PARTS & SERVICE NEWS

REF NO. AA04052A

SUBJECT: REPAIR PROCEDURE OF LIGHTING SWITCH

PURPOSE: To introduce modification procedure to repair when the contact section of the lamp lighting switch becomes damaged to cause melting failure or impossibility of turning on the lamp

Fig. 1

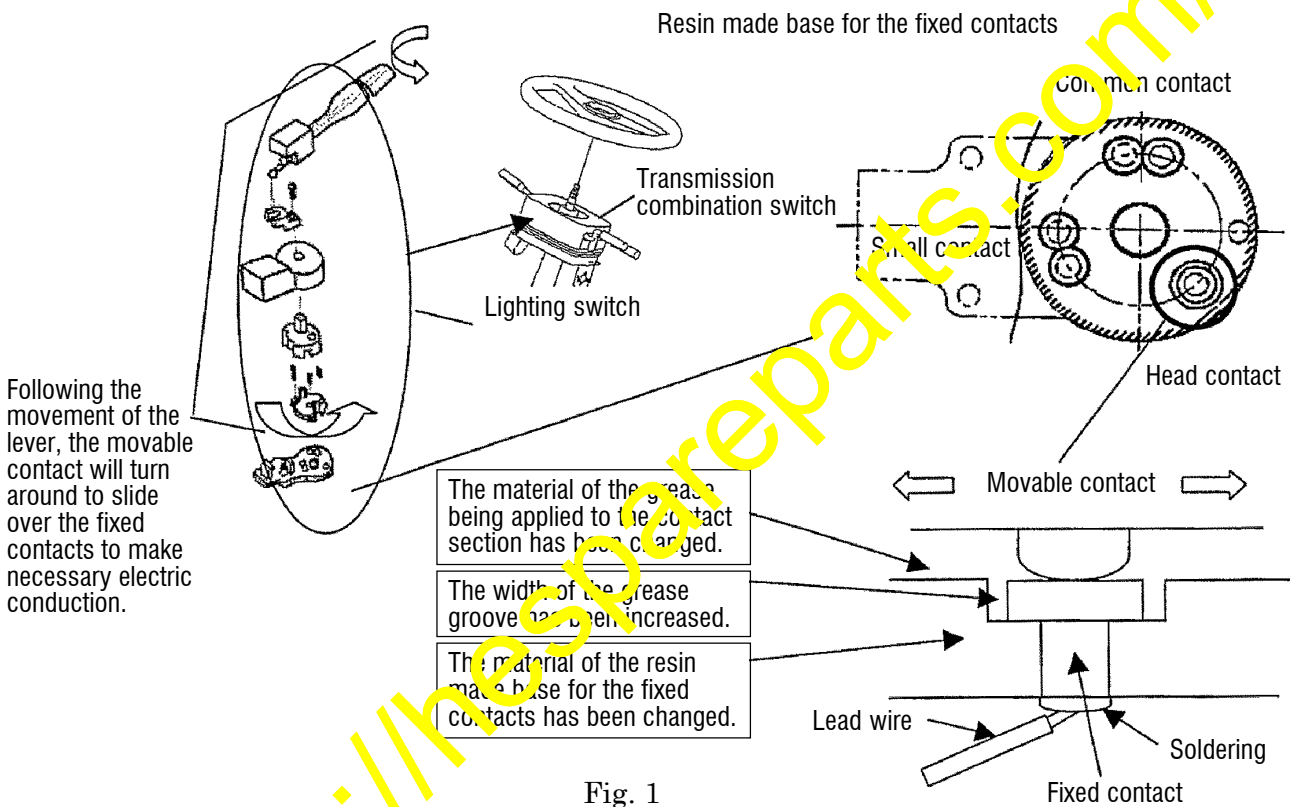
- ① Replace the lamp switch with a new one with increased durability.
 - 1) By increasing the width of the grease groove made around the sliding contacts and fixed contact terminals (0.15 mm → 0.8 mm), worn resin powder can be kept from riding on the surface of the contact thus preventing to form an electric resistance against the contact and to generate heat.
 - 2) By changing the material of the resin made base for the fixed contact terminals and by changing the material of the grease to be applied between the movable contact and the fixed contacts into new materials possessing higher abrasion resistance, thus preventing occurrence of the above failure.

Fig. 2

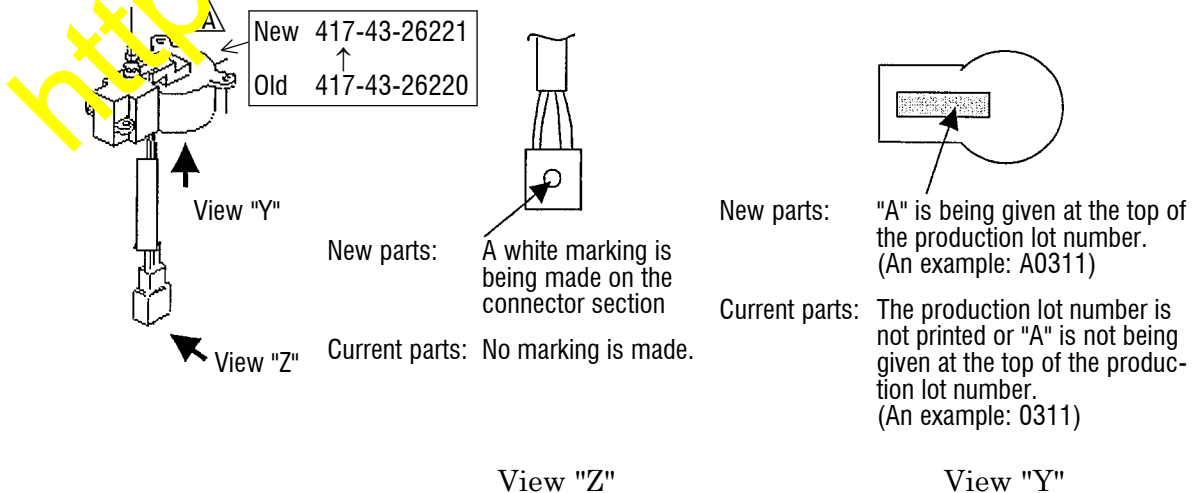
[Identification method to distinguish from the current parts]

Fig. 3

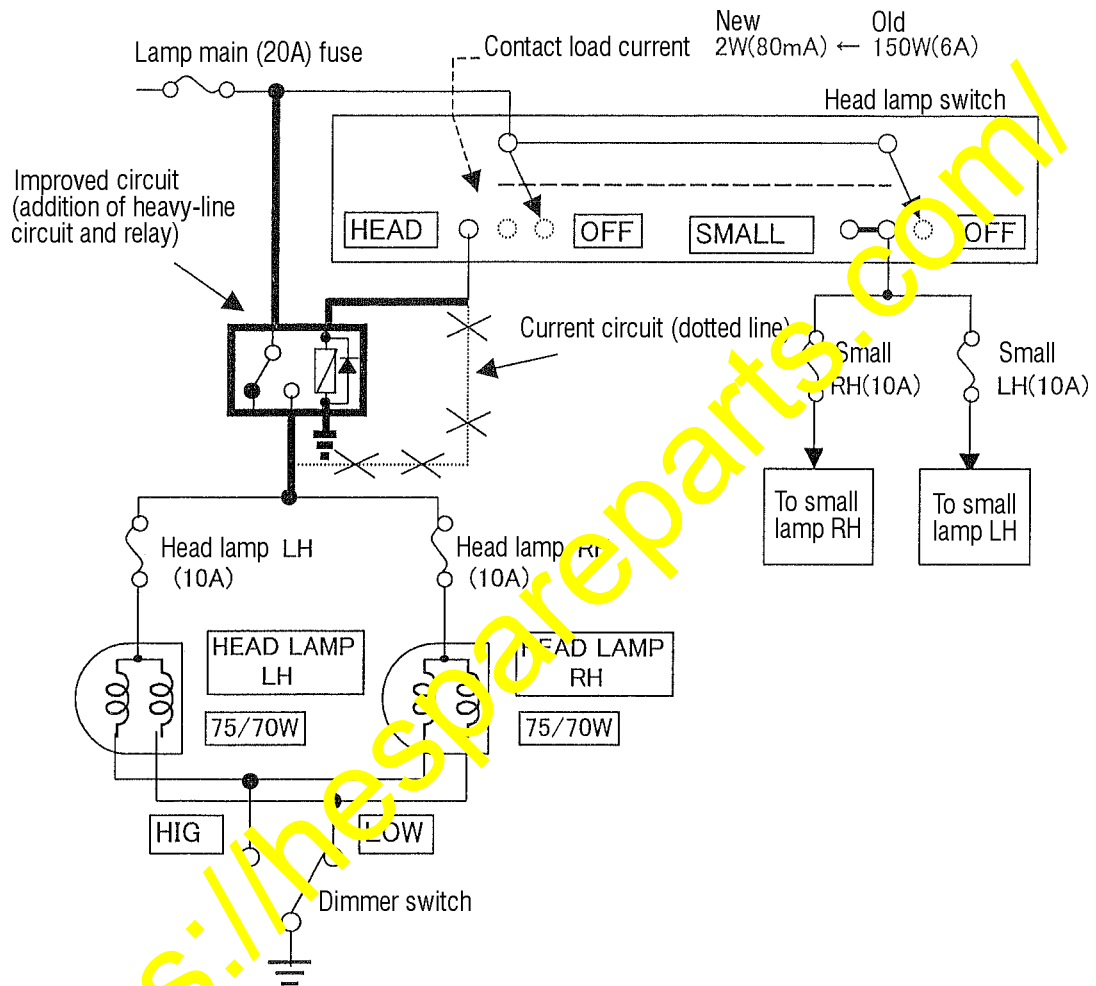
- ② To reduce load current on the head lamp switch contact, change the circuit and add a relay between the switch and the lamp.

Fig. 9

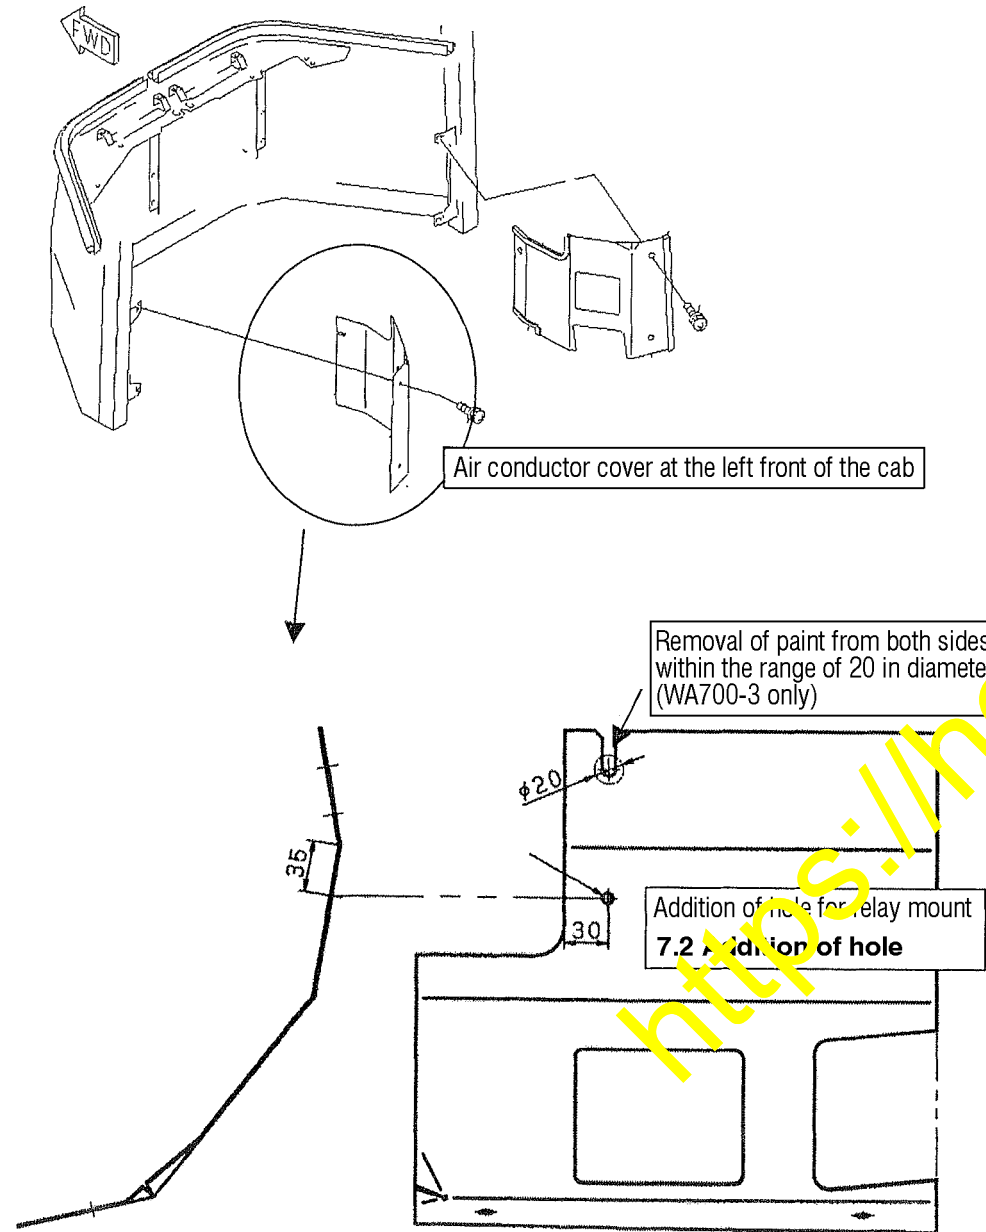
Step 1) Conduct additional work to make the head lamp relay mounting hole (For details, see Fig. 9.)

Step 2) Remove paint from the installed position of the grounding terminal and apply rust preventing oil (For details, see Fig. 9.)

Fig. 10

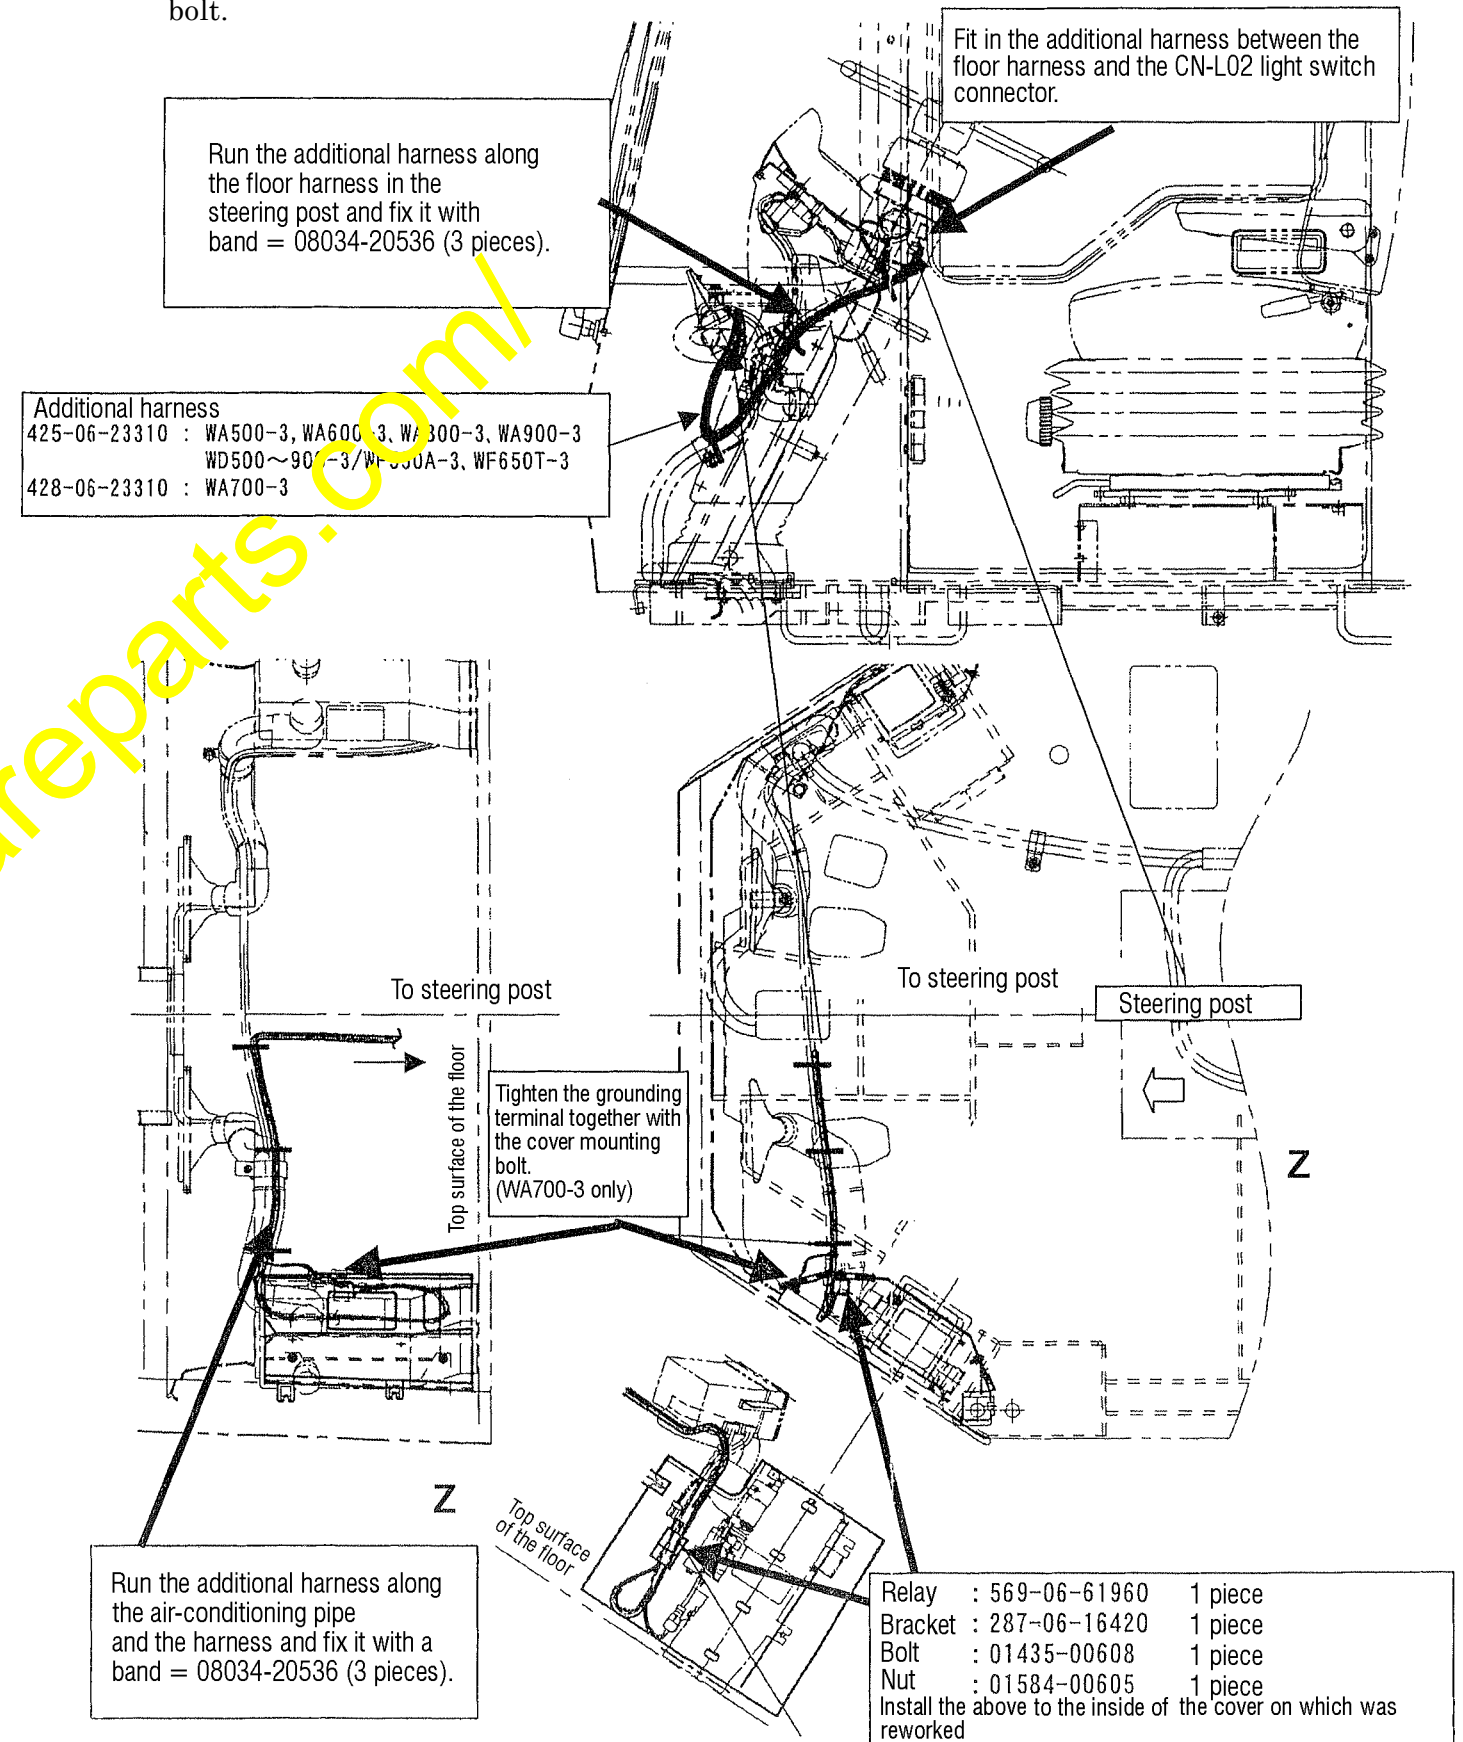
Step 3) Install a relay on the cover at the left front of the cab on which additional work was conducted (For details, see Fig.10.)

Step 4) After connecting the additional harness to the relay installed and fix it to the floor harness with a band, then connect the interrupt connector to the CN-L02 connector in the steering post. Tighten the ring terminal for the additional harness ground together with the cover mounting bolt.

Fig. 12

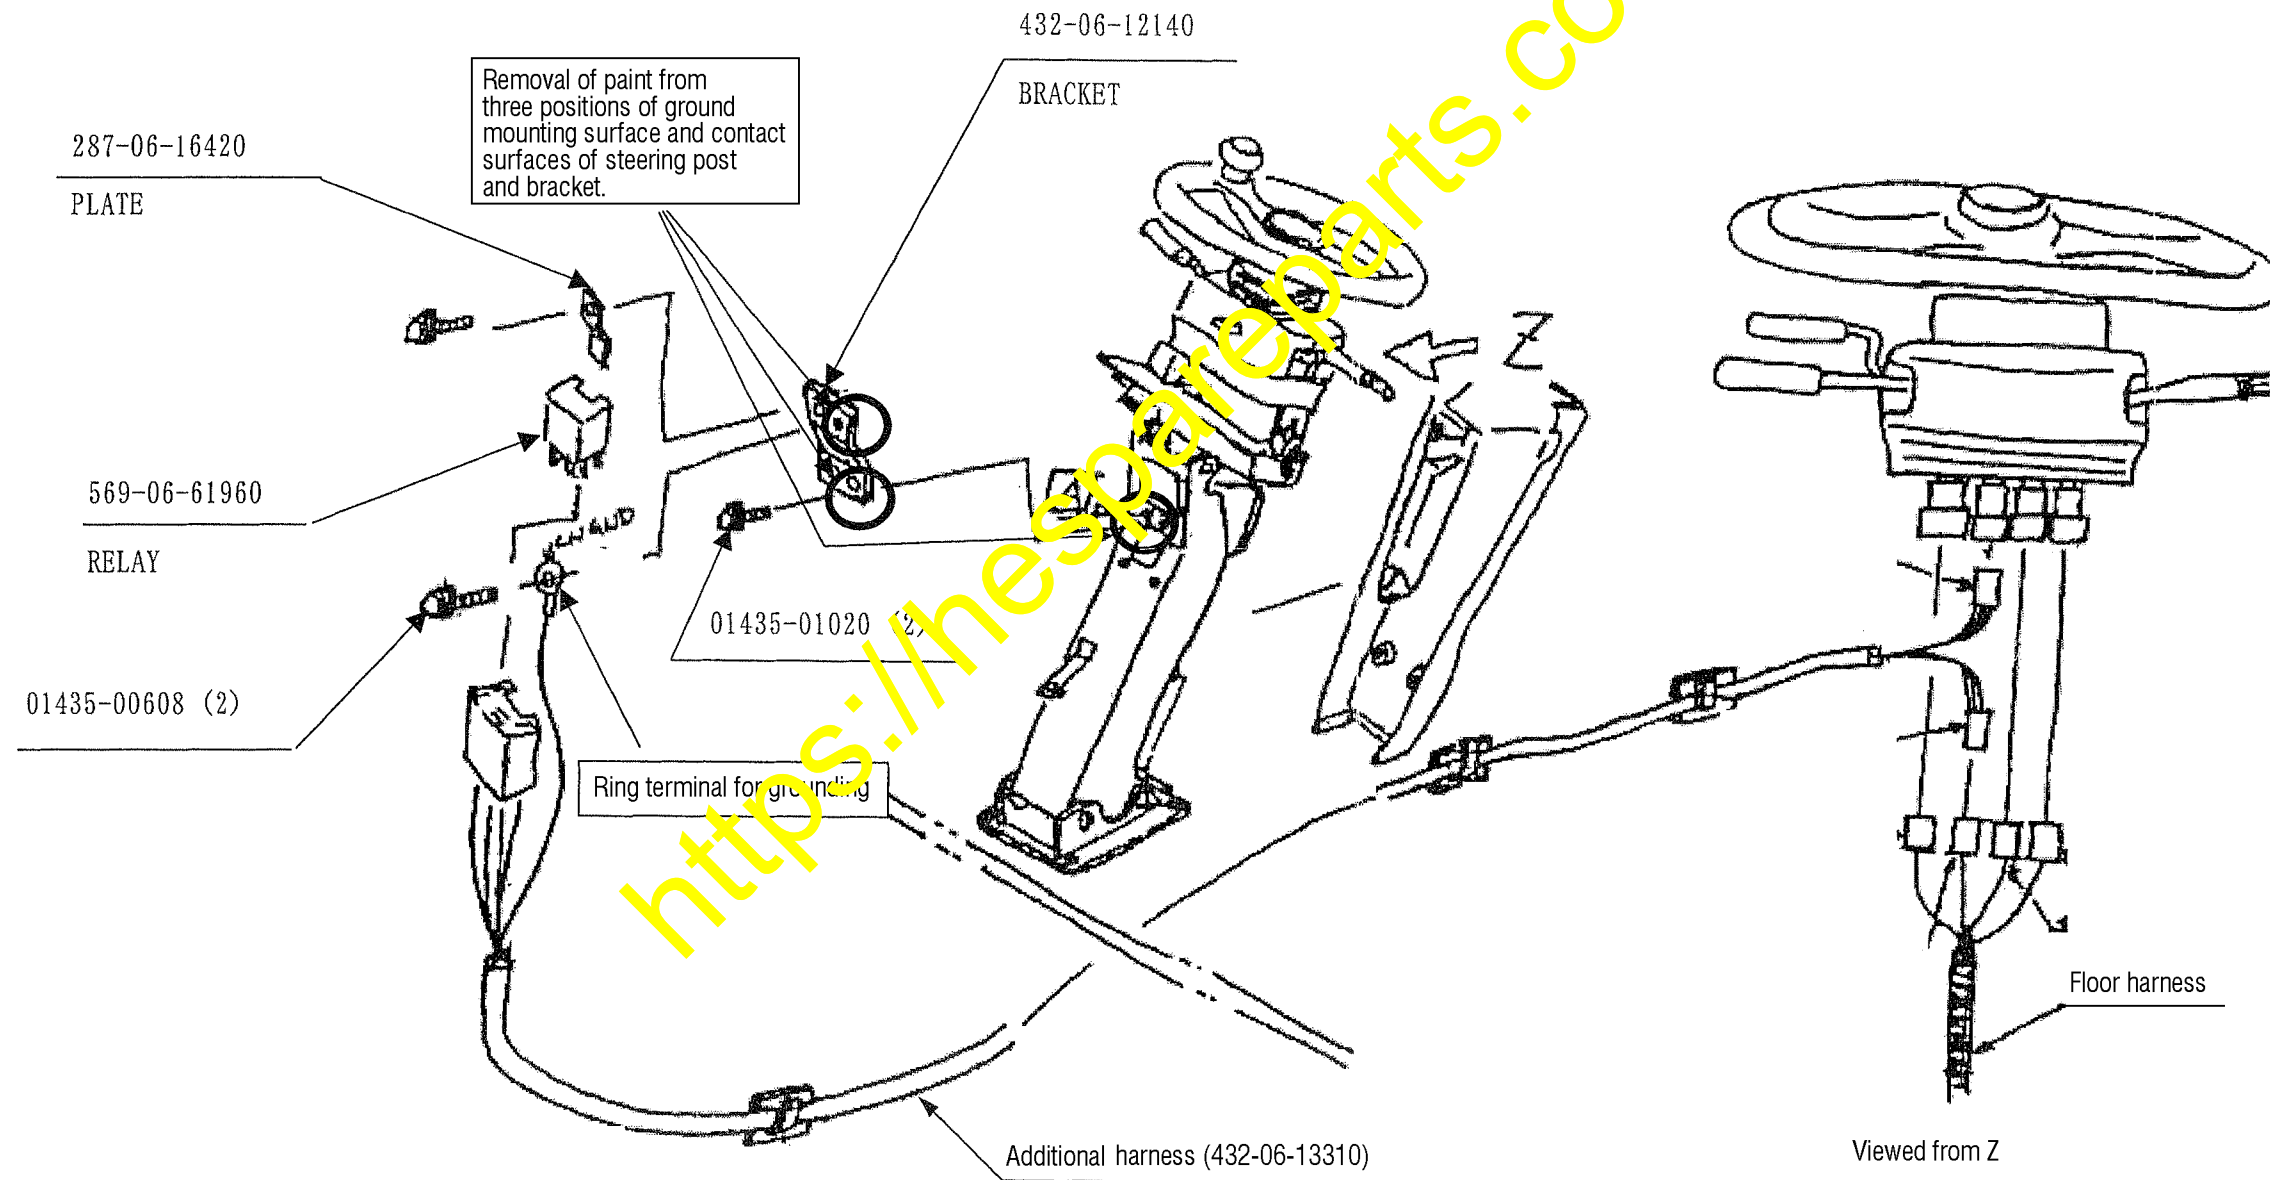
- Step 1) Remove paint from the relay fixing bracket and steering post mounting surface and the installed position of the grounding terminal (For details, see Fig. 12.)
- Step 2) Install the head lamp relay at the back of the steering post, using the bracket and plate (For details, see Fig.12.)
- Step 3) After connecting the created harness to the relay installed, connect the interrupt connector to the head lamp switch connector in the steering post and ground the ring terminal to the bracket with the bolt.
